Addendum #7

CONSIDER IN YOUR RESPONSE/BID THE FOLLOWING ITEMS OF ADDITION, DELETION OR CLARIFICATION. INDICATE IN THE SPACE PROVIDED ON THE RESPONSE/BID FORM THAT YOU HAVE RECEIVED AND INCLUDED FOR THE REQUIREMENTS OF THIS ADDENDUM. SICKKIDS MAY, IN ITS SOLE DISCRETION ANSWER SIMILAR QUESTIONS FROM VARIOUS RESPONDENTS ONLY ONCE.

RE: QUESTIONS AND ANSWERS, SPECIFICATIONS, DRAWINGS AND DOCUMENTS

MW 02 EW 01

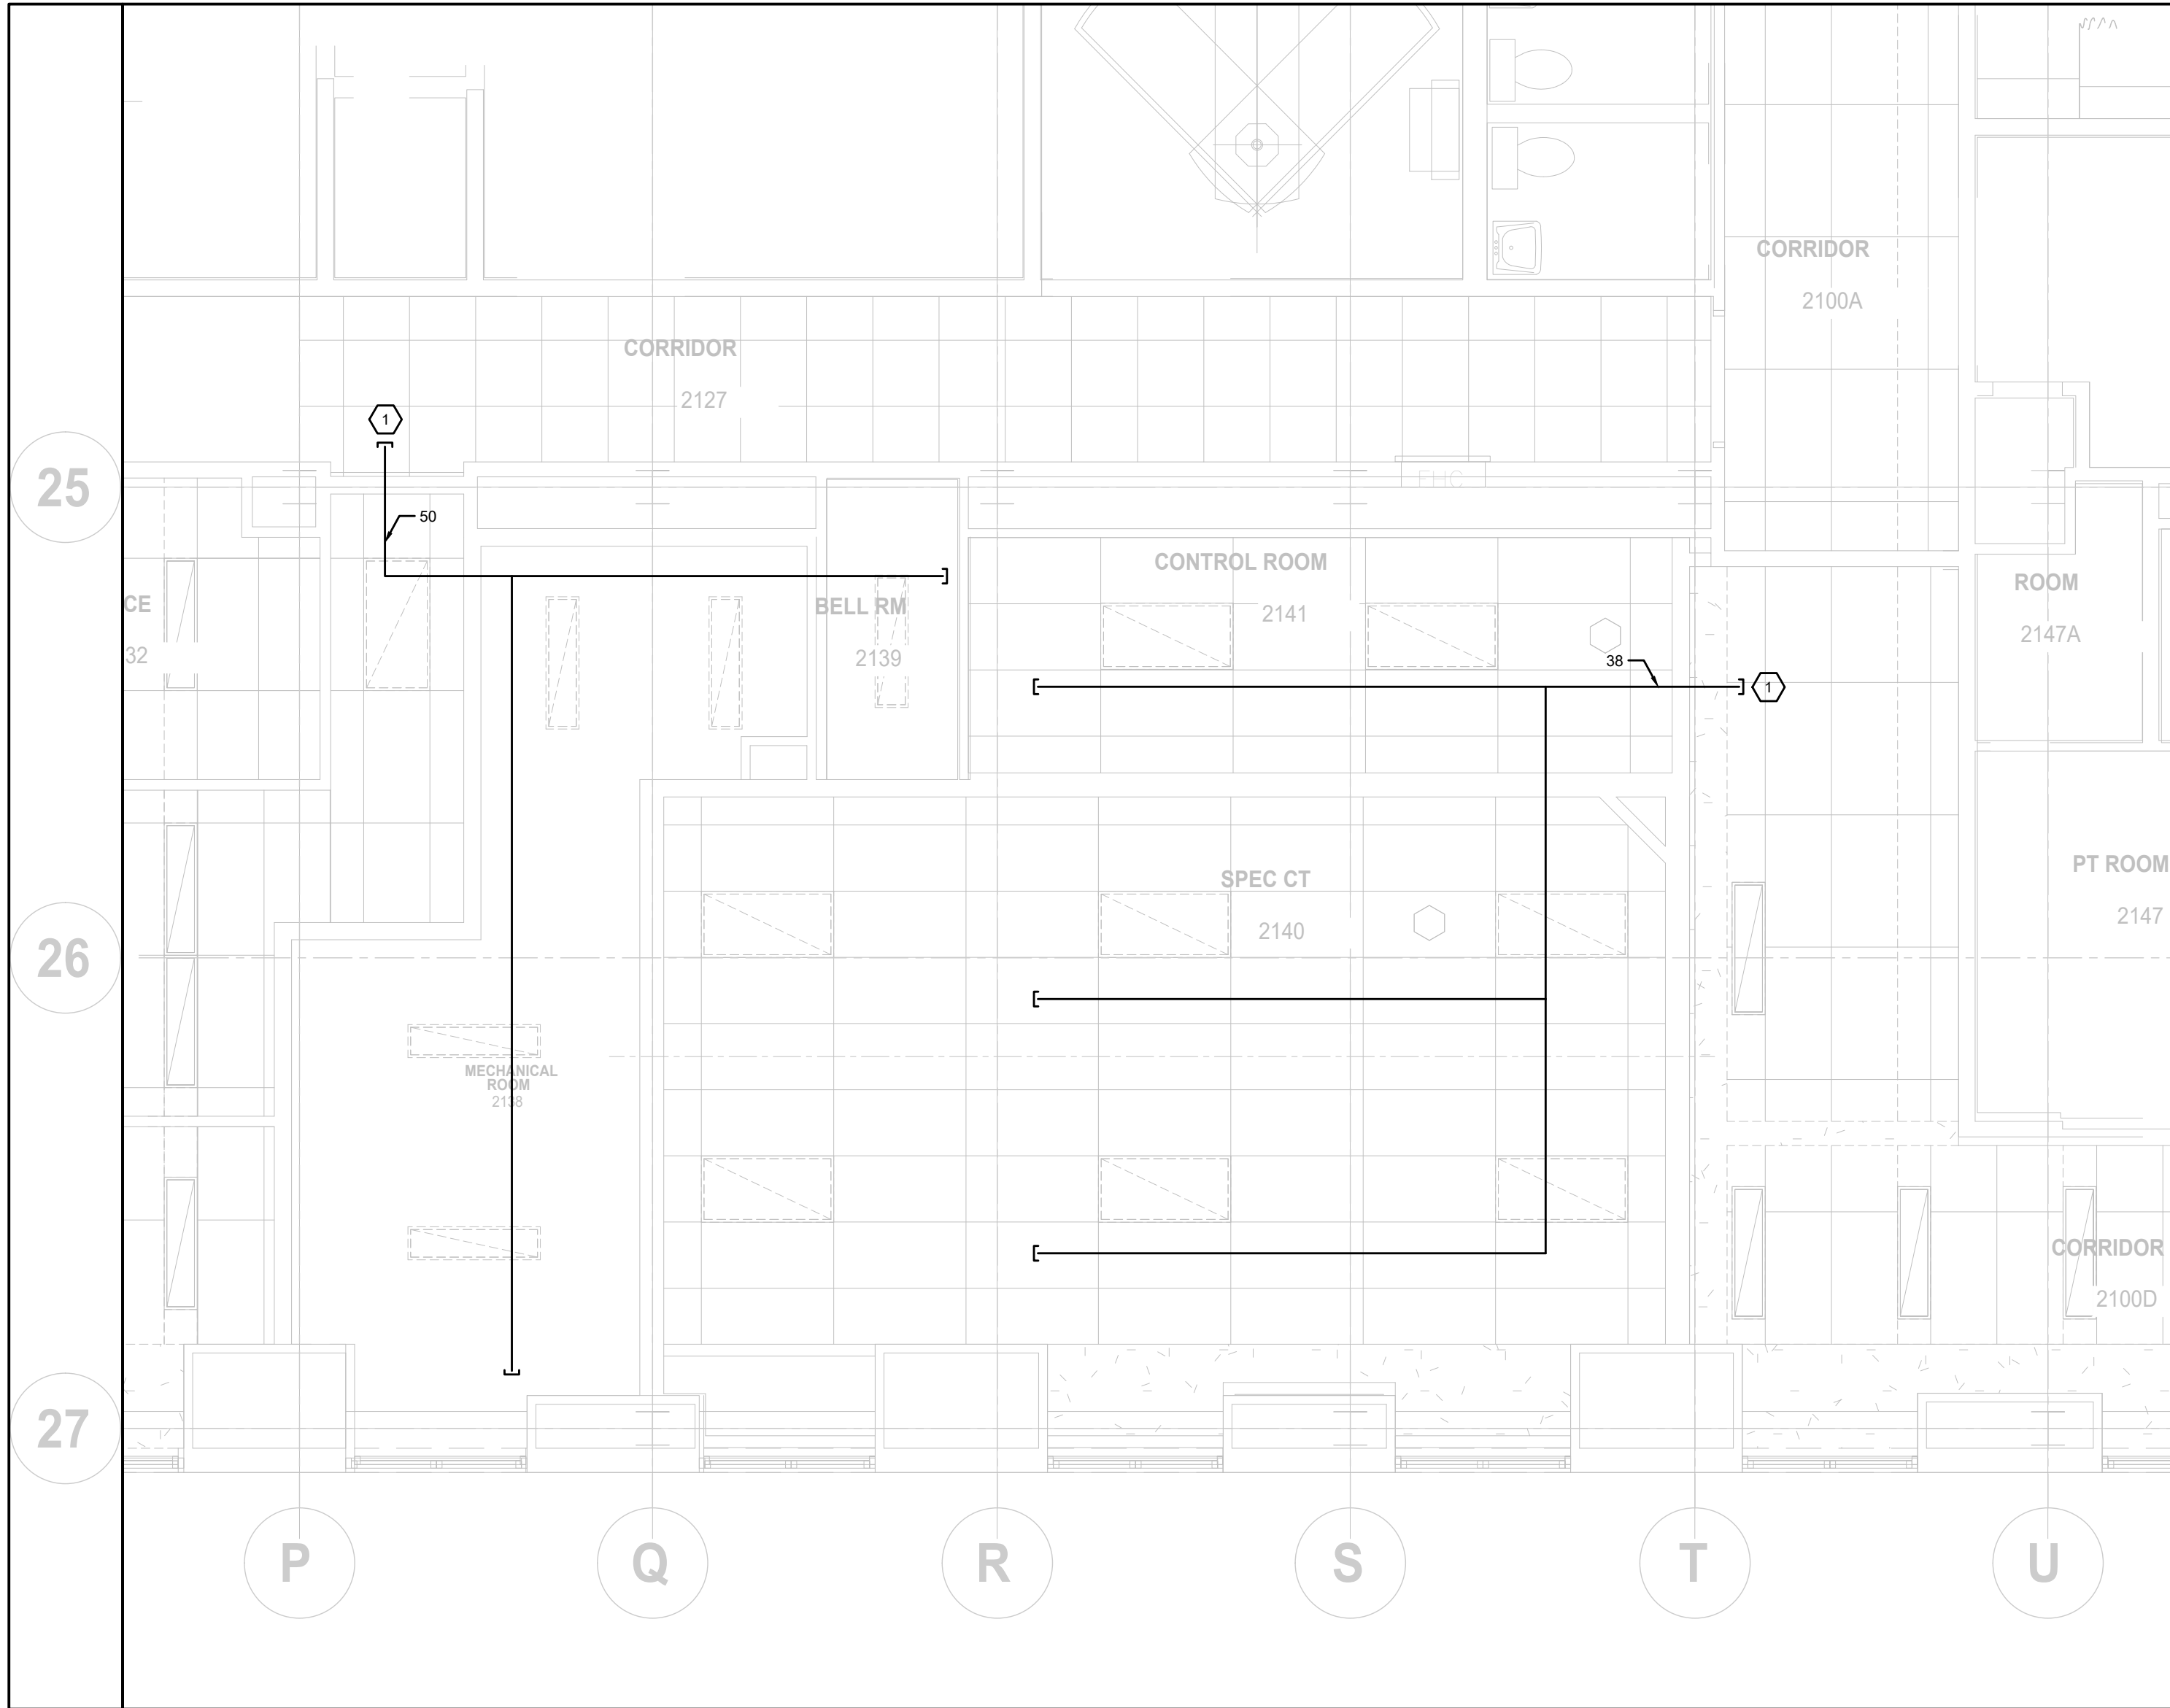
9. **Drawing MW 02 EW 01 – LEVEL 2 PART PLANS – FIRE PROTECTION.**
